DEVELOPMENT REVIEW BOARD
SUPPLEMENTAL SUBMITTAL

PROJECT NO. PR-2021-006070

Re: Westpointe40 North Site Plan DRB Comment Responses (PR-2021-006070)

This memo outlines the responses and changes made to the site plan for the proposed 150K spec industrial building at Westpointe40 based on the comments received and reviewed at the December 1, 2021 DRB meeting. The comments are numbered and followed by the response in italics.

EXTERIOR ELEVATIONS

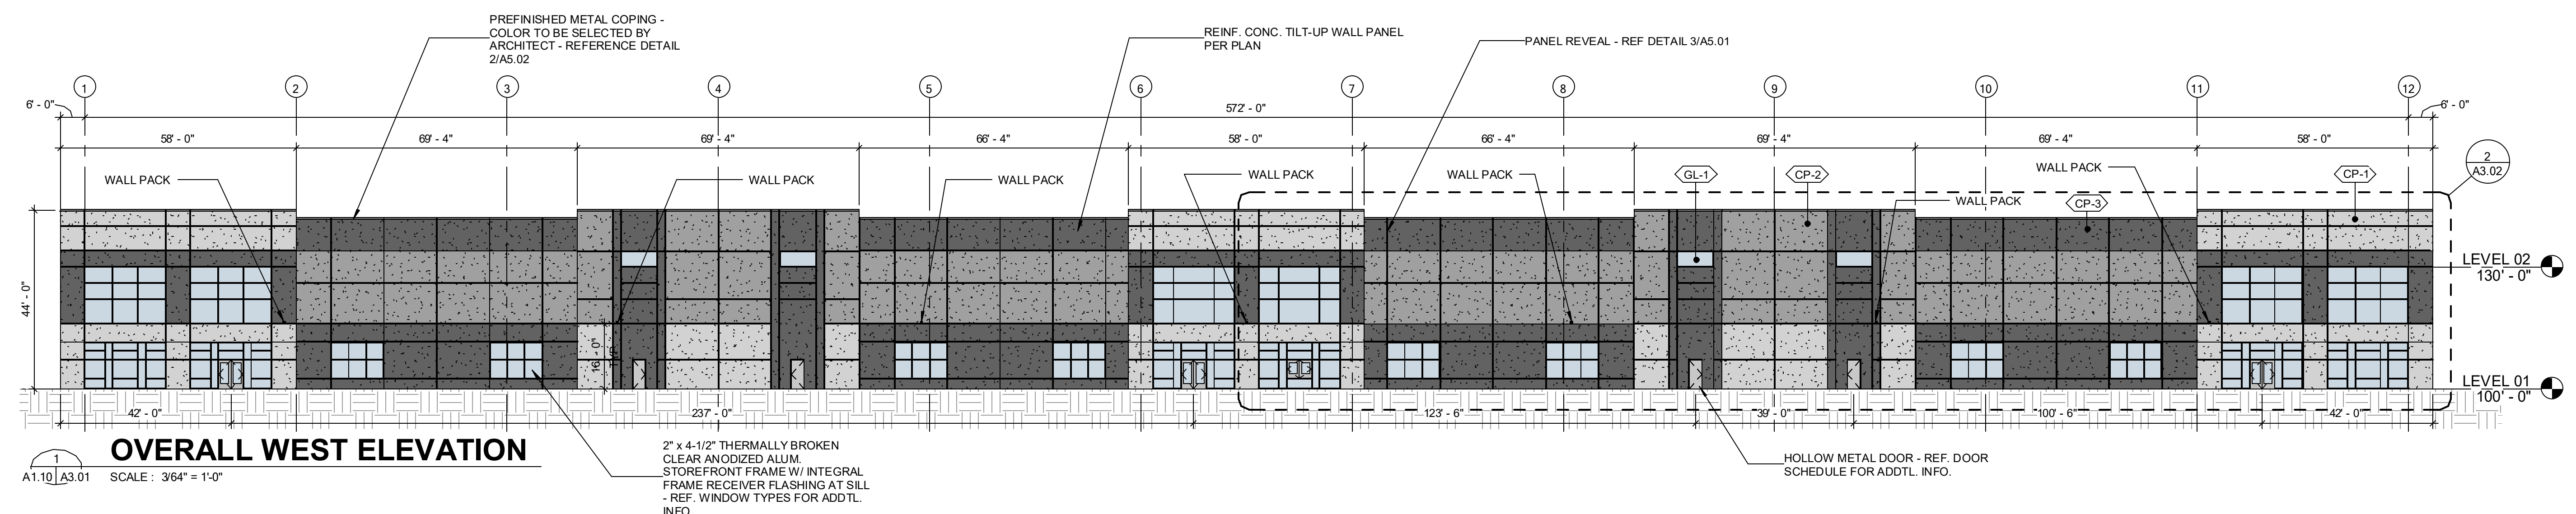
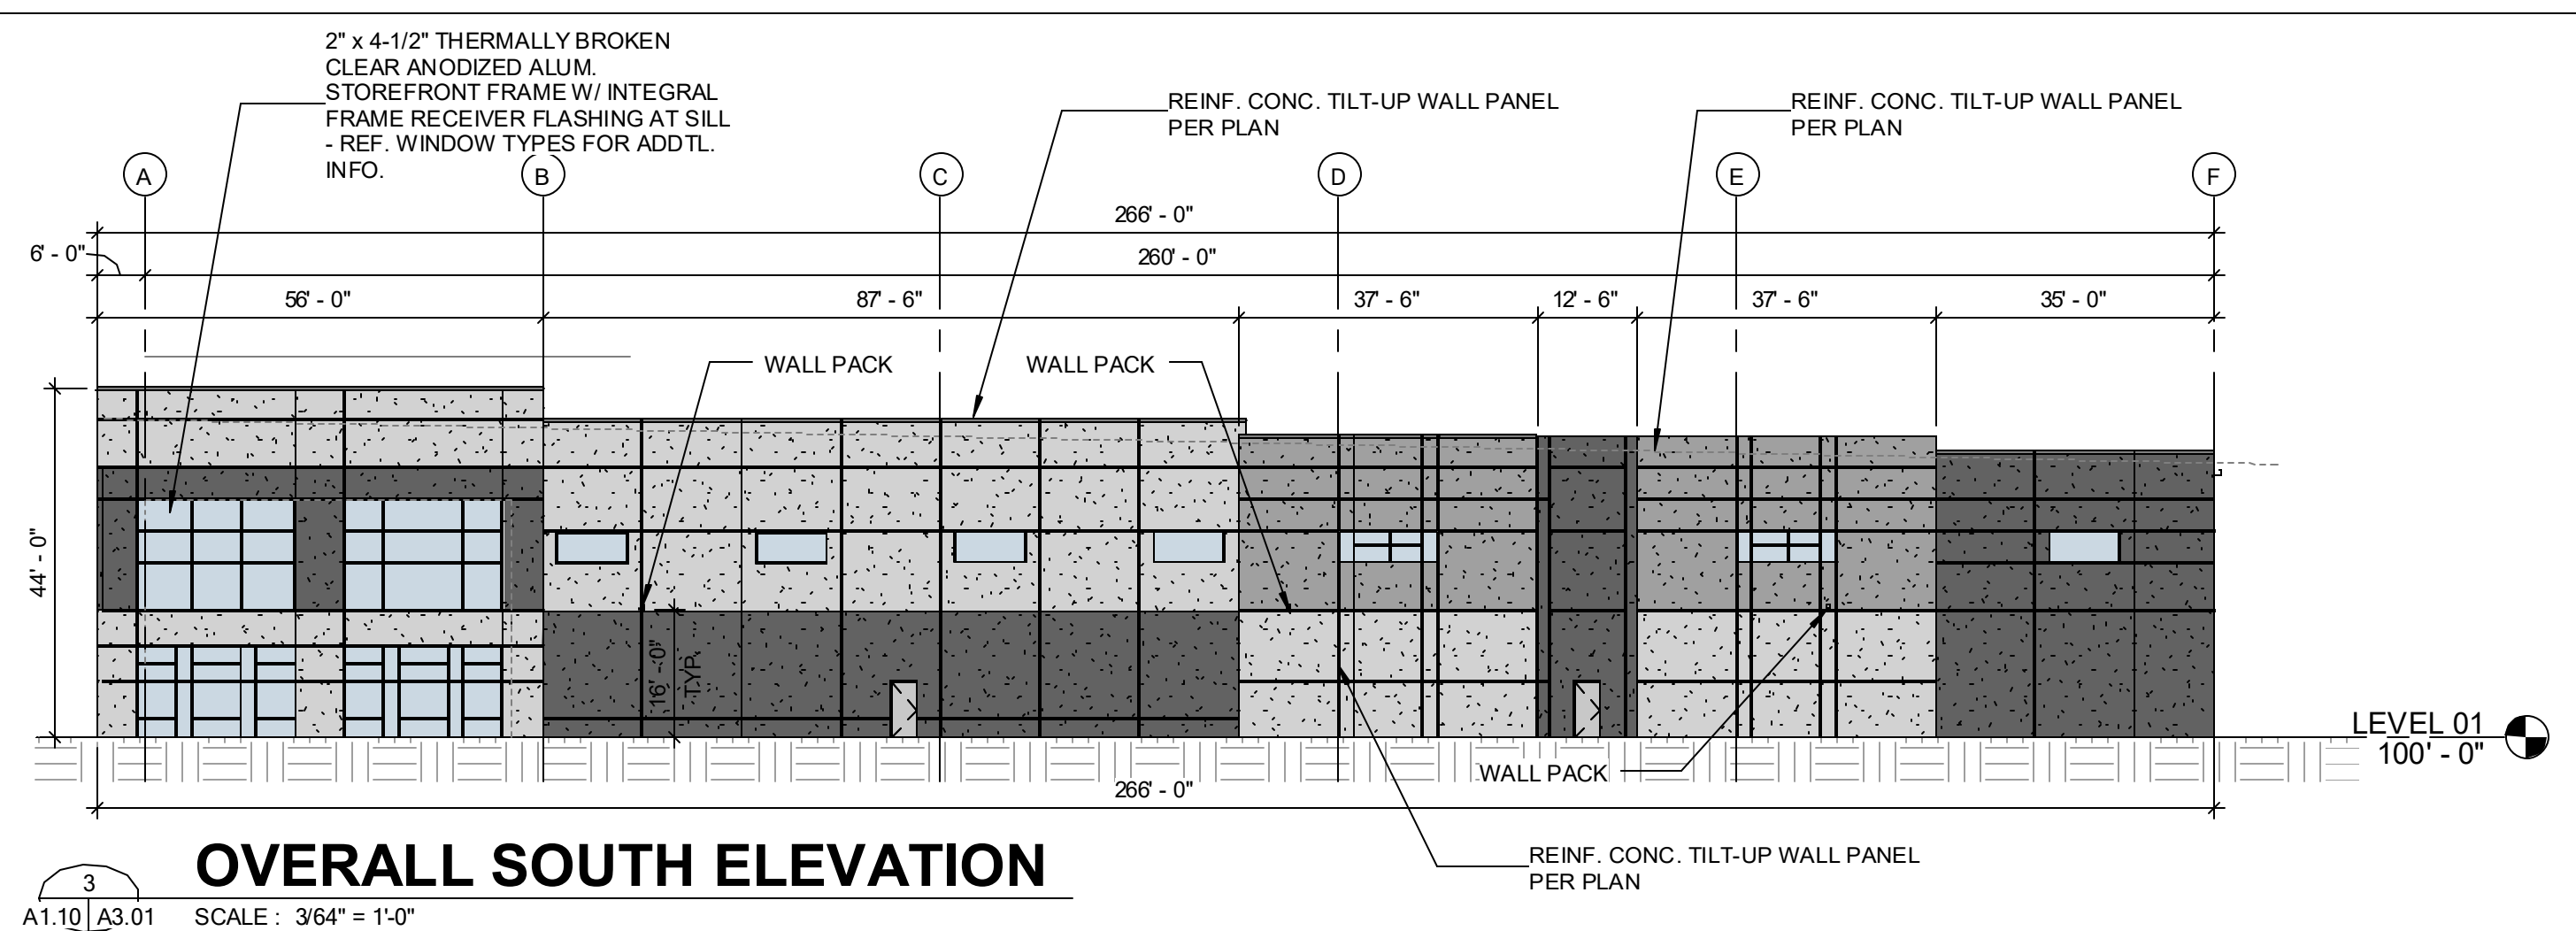
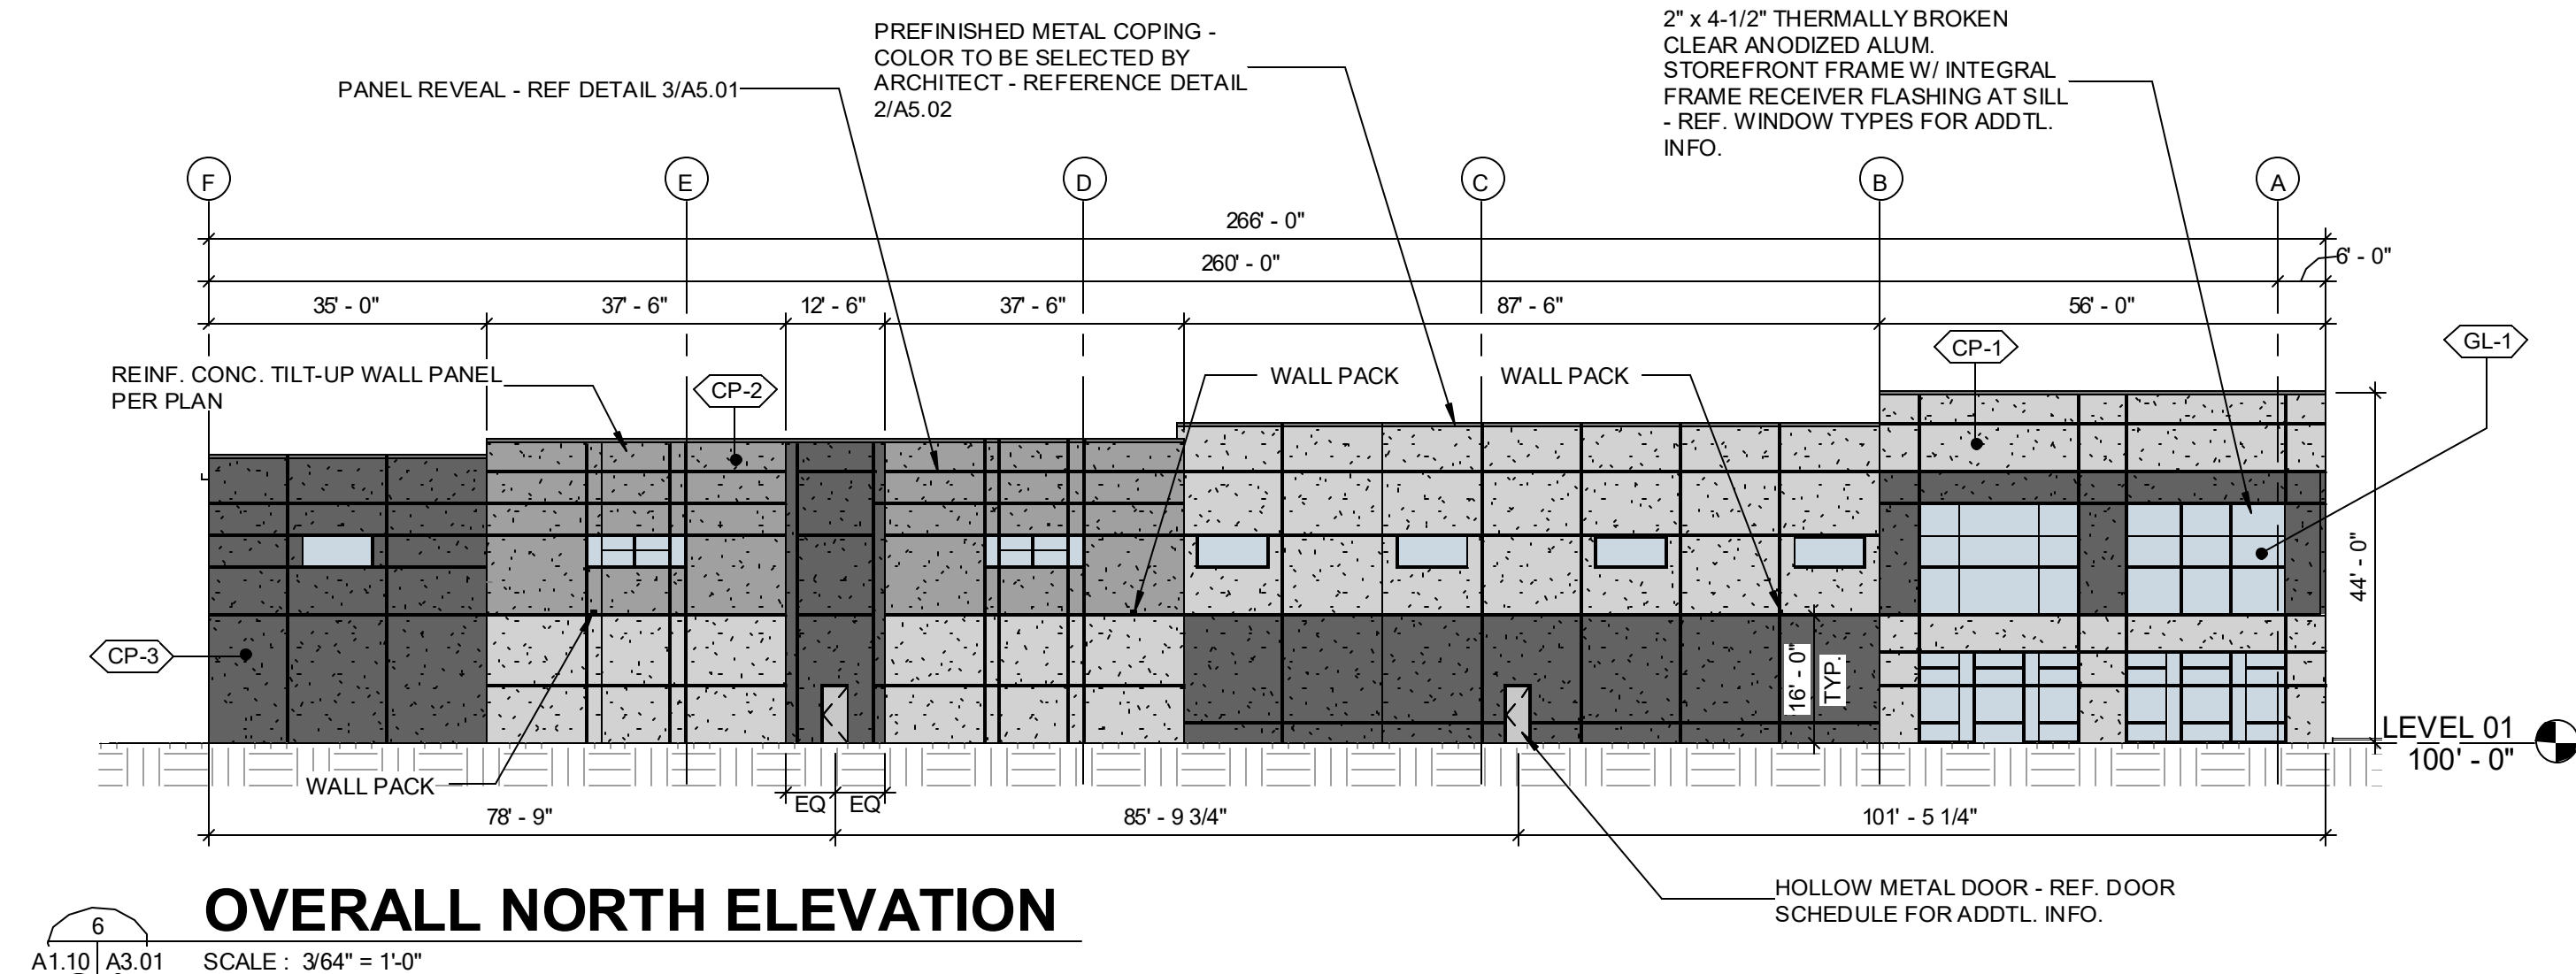
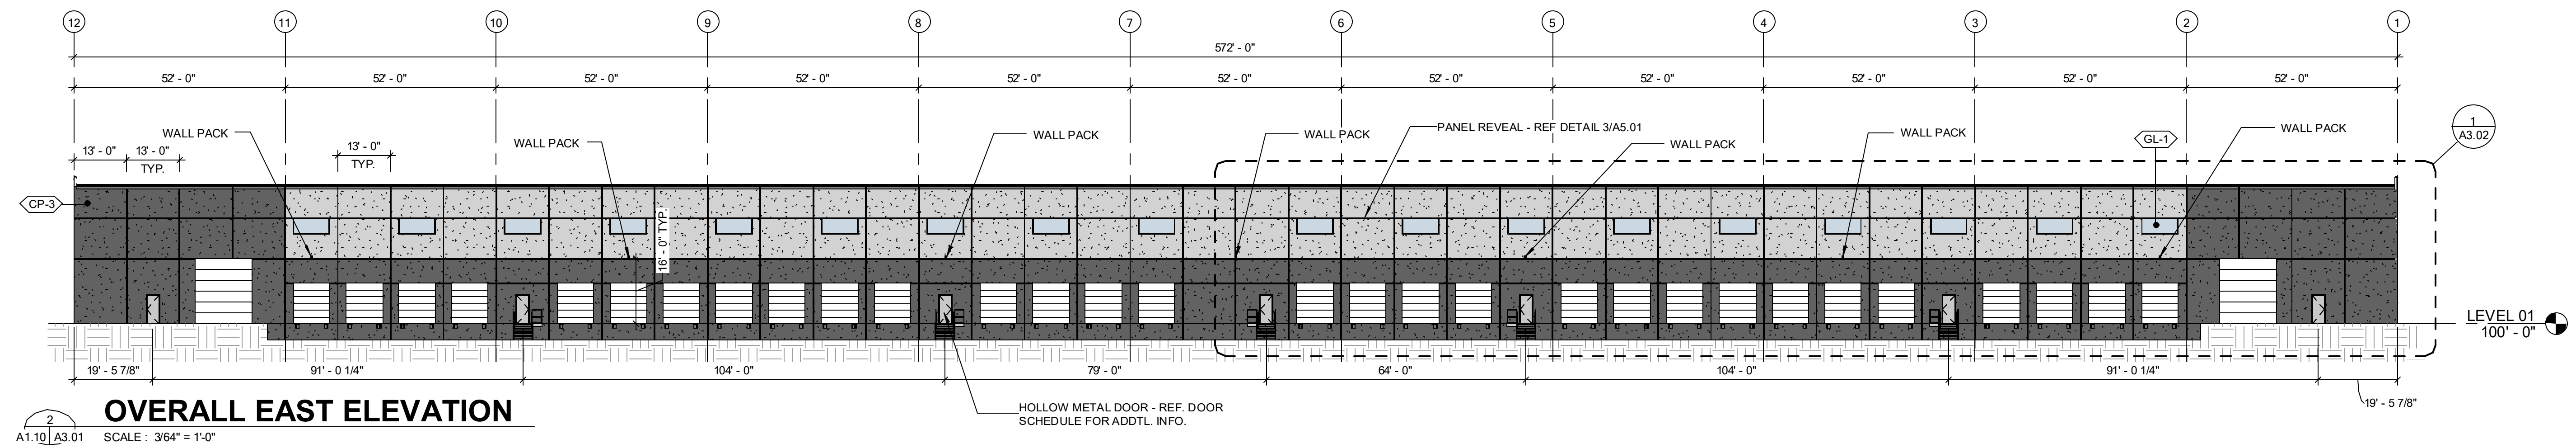
8. Additional detail needed for meeting Façade Design general standards, IDO section 5-11-E.
 - *Despite the large size and function of the building, a human scale is provided along the primary building façade through a differentiation in colors and use of windows and doors around entries.*

- *The building is setback more than 30 feet from Daytona Road, so it does not meet the definition of a street-facing façade and therefore is not required to meet the standards outline in Section 5-11(E)(2)(a)2. However, the applicant has taken care to provide visible primary pedestrian entrances and the use of ground floor windows to improve the overall look and feel of the building from the parking lot.*

- *While it is not considered a street-facing façade, the west elevation breaks up its length using a change in parapet heights and building articulation every 60 to 70 feet, as well as using multiple colors along the entire length of the façade.*

DAYTONA RD SECTION

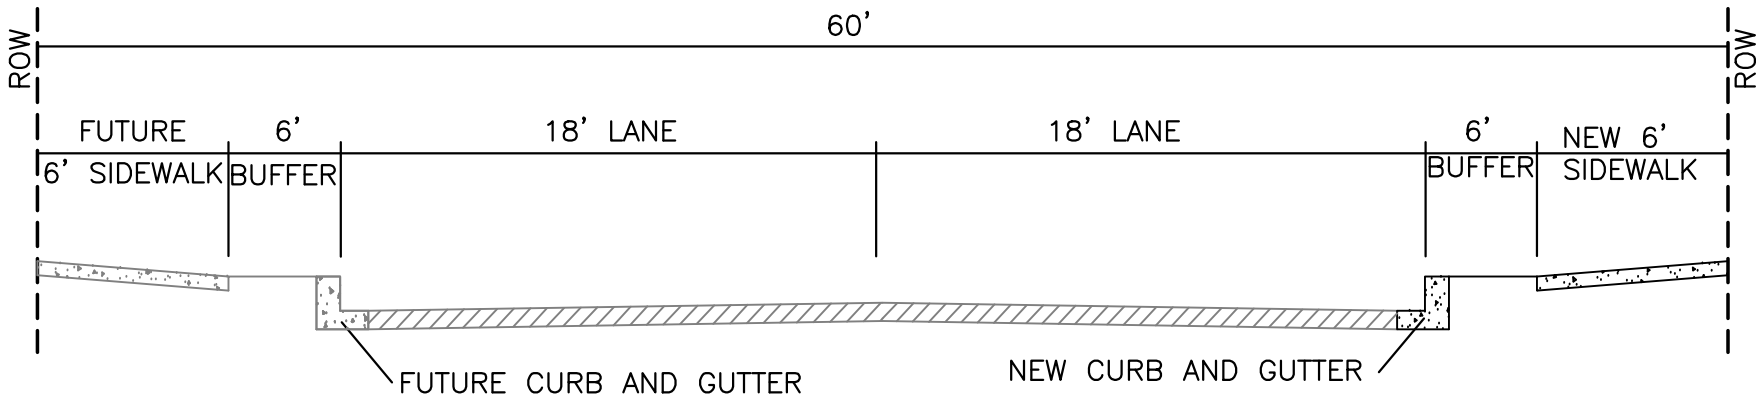
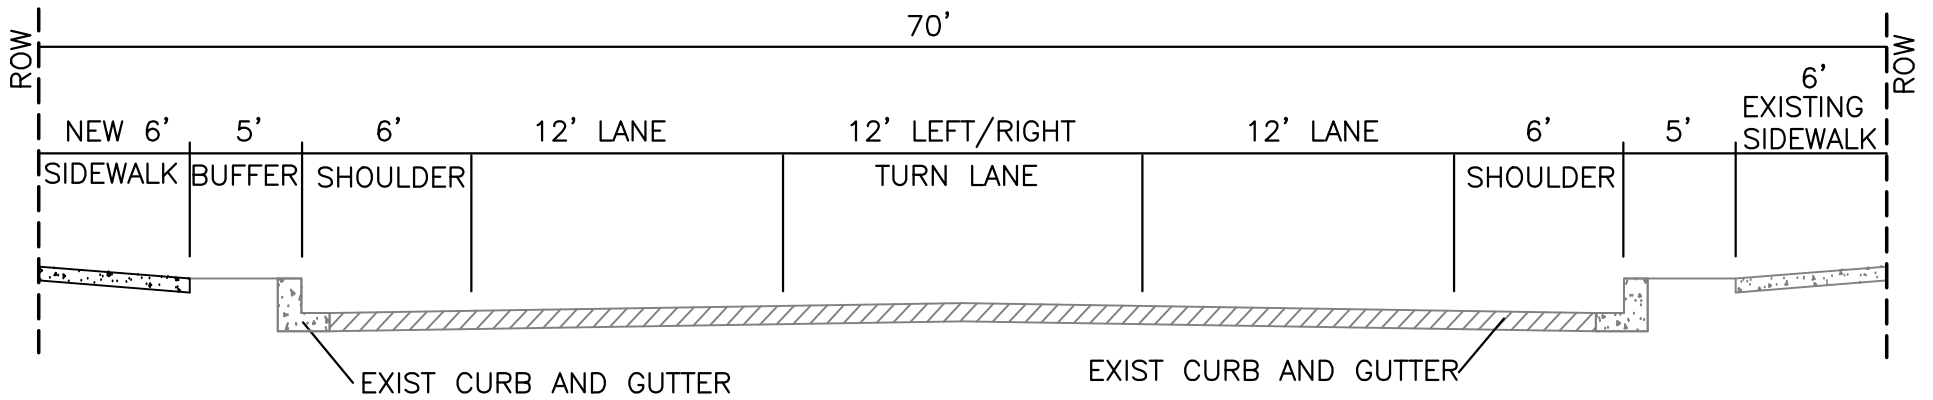
3. Show cross-section of adjacent road to include the new sidewalk, curb, and landscape buffer.
 - *Roadway cross sections are included in the supplemental submittal information.*
